25 097

14 May 2025

**Re: Hearing 10 – Peer Review of Vision Consulting Engineers *High Level Civil Engineering Assessment*, Tapuaetahi Development, prepared for Tapuaetahi Incorporation**

*Figure 1: Mapped flood hazard downstream of Site*

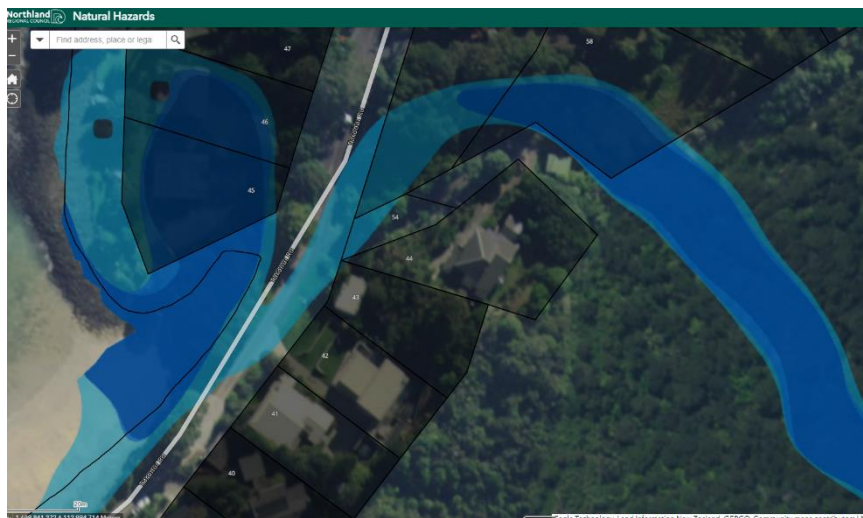
The mapped flood hazard of Waiotia stream follows the stream alignment to the outlet at the north end of Tapuaetahi beach where it is indicated that buildings located at 45 and 46 Taronui Road may be prone to flooding in the 10-year, 50-year and 100-year plus climate change events (see Figure 1).

The Site naturally drains to the northeast into the bush clad valley of Waiotia stream where stormwater promulgates before discharging to the sea at the north end of Tapuaetahi beach. As 45 and 46 Taronui Road are potentially impacted by river flooding downstream of the site, a detailed stormwater assessment will be required to ensure that downstream flood hazards are not worsened<sup>3</sup>

Figure 2: Sight distance to the south (source: google maps)

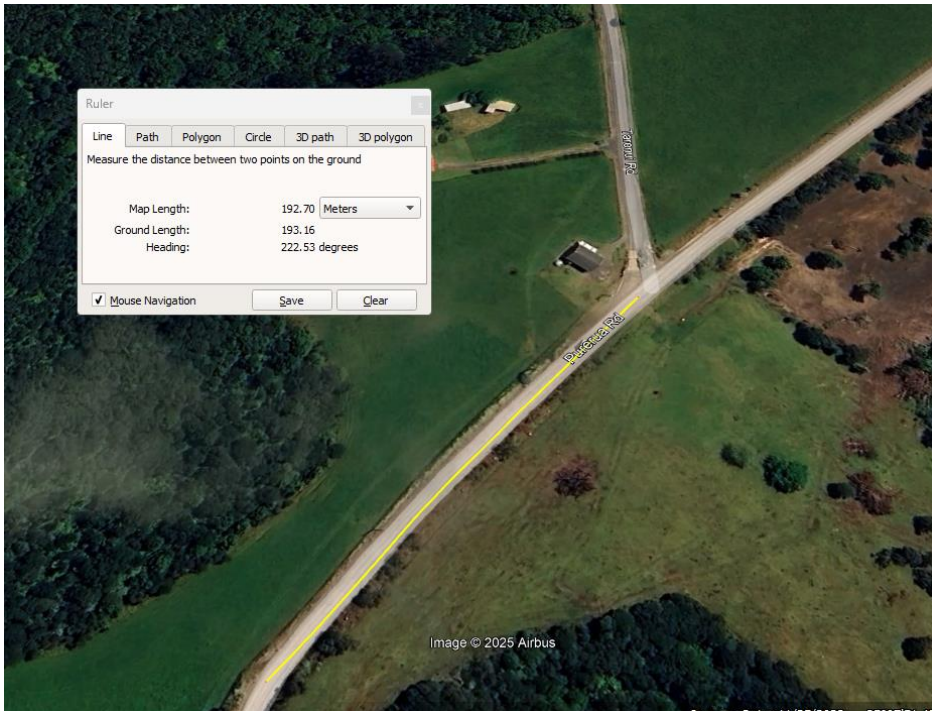
It is assumed that the existing vehicle crossing onto Purerua road will be retained. There is approximately 190 m sight distance to the south (see figure 2 and 3) and 500 m to the north from the existing vehicle crossing.

standards is 195 m for a low volume access, or 210 m for a secondary collector. However, FNDC speed limit changes rolled out in 2024 indicate that Purerua road from 100 m before Te Tii Road to the end is reduced from 100 km/h to 60 km/hr, for which the minimum sight distance reduces to 85 to 90 m. Whilst the Proposed District Plan relies on posted speed limit for determining safe sight distance, Operating speed based upon a traffic survey will likely be the governing criteria for determining safe sight distances.

An Integrated Transport Assessment is required to determine any safety issues and upgrade requirements for the development, however it is likely that safe access is able created to support future development.

Figure 4: Alternative vehicle crossing to Taronui Road.

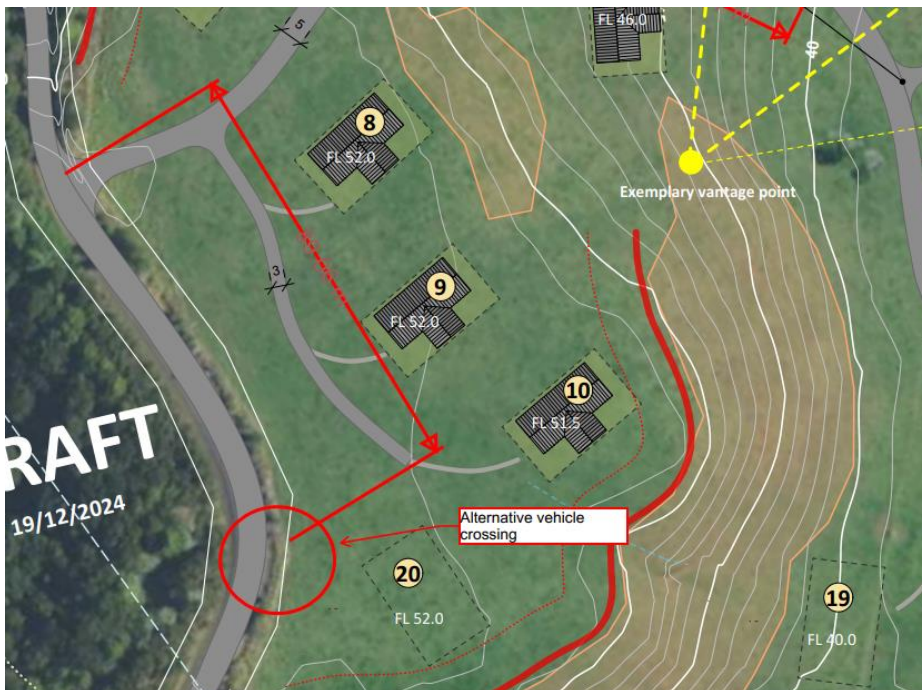
The proposed vehicle crossing location may not provide adequate sight distance to the north and repositioning may be required. A more suitable location may be available 90 m to the south of the currently drawn position (see Figure 4).

The location of the vehicle crossing indicated on the concept plan will require consideration as part of the Integrated Transport Assessment. Again, it is likely that safe access is able to be created to support future development.
